Docket Number:	13-AFC-01C
Project Title:	Alamitos Energy Center - Compliance
TN #:	224233
Document Title:	Notice of Determination and Staff Approval Petition to Amend for the Temporary Use of an Additional Construction Laydown Area
Description:	N/A
Filer:	Patty Paul
Organization:	California Energy Commission
Submitter Role:	Commission Staff
Submission Date:	7/20/2018 4:51:53 PM
Docketed Date:	7/20/2018

**NOTICE OF DETERMINATION AND STAFF APPROVAL
PETITION TO AMEND
FOR THE TEMPORARY USE OF AN ADDITIONAL CONSTRUCTION
LAYDOWN AREA
AT THE ALAMITOS ENERGY CENTER
(13-AFC-01C)**

**Environmental Justice – Table 1
Low Income Data within the Project Area**

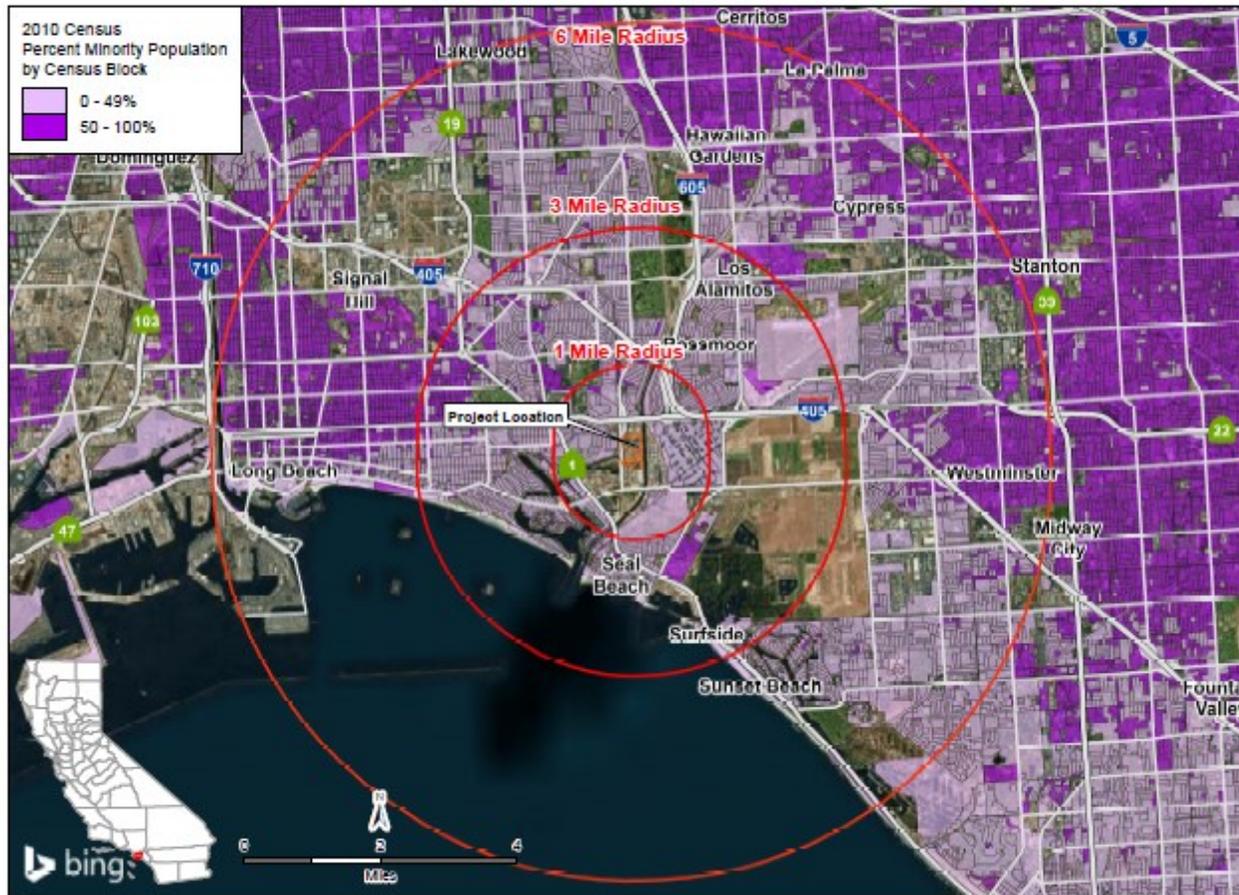
Based on California Department of Education data in the **Environmental Justice – Table 1** and presented in **Environmental Justice – Figure 2**, staff concluded that the percentage of those living within the Westminster Elementary School District (in a six-mile radius of the project site) and enrolled in the free or reduced price meal program is larger than those in the reference geographies, and thus are considered an environmental justice (EJ) population based on low income as defined in *Guidance on Considering Environmental Justice During the Development of Regulatory Actions*.

ENVIRONMENTAL JUSTICE - FIGURE 1
Alamitos Energy Center - Census 2010 Minority Population by Census Block

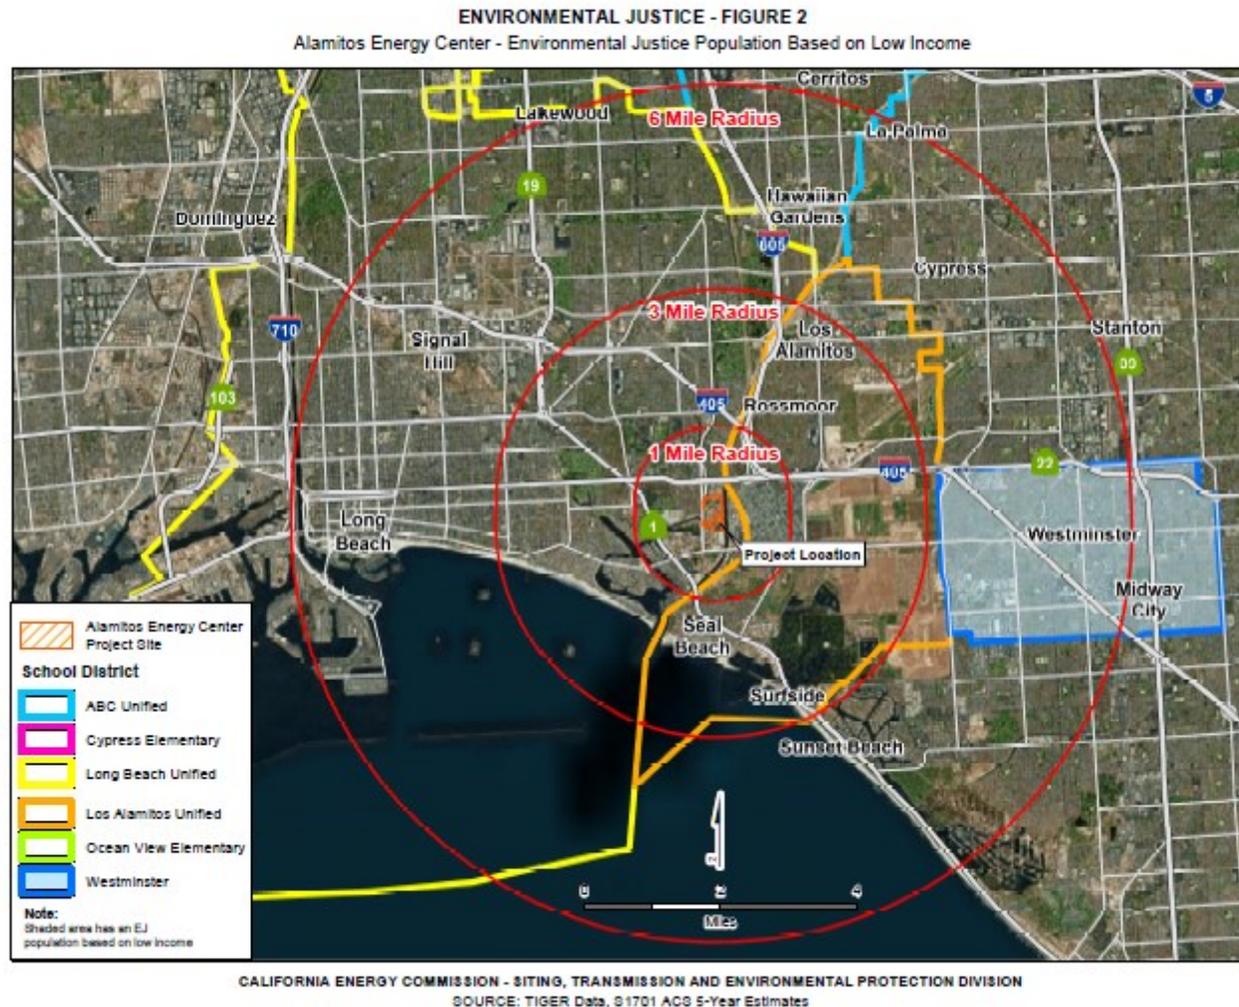
The **Environmental Justice – Figure 1** shows 2010 census blocks in the six-mile radius of AEC contain a minority population greater than or equal to 50 percent. The population in these census blocks represents an EJ population based on race and ethnicity as defined in the United States Environmental Protection Agency's *Guidance on Considering Environmental Justice During the Development of Regulatory Actions*.

Energy Commission staff identified less than significant impacts in each of the technical areas listed above with the implementation of existing conditions of certification. Therefore, impacts would be less than significant for any population in the project’s six-mile radius, including the EJ population represented in **Environmental Justice - Figure 1 and 2, and Table 1**.
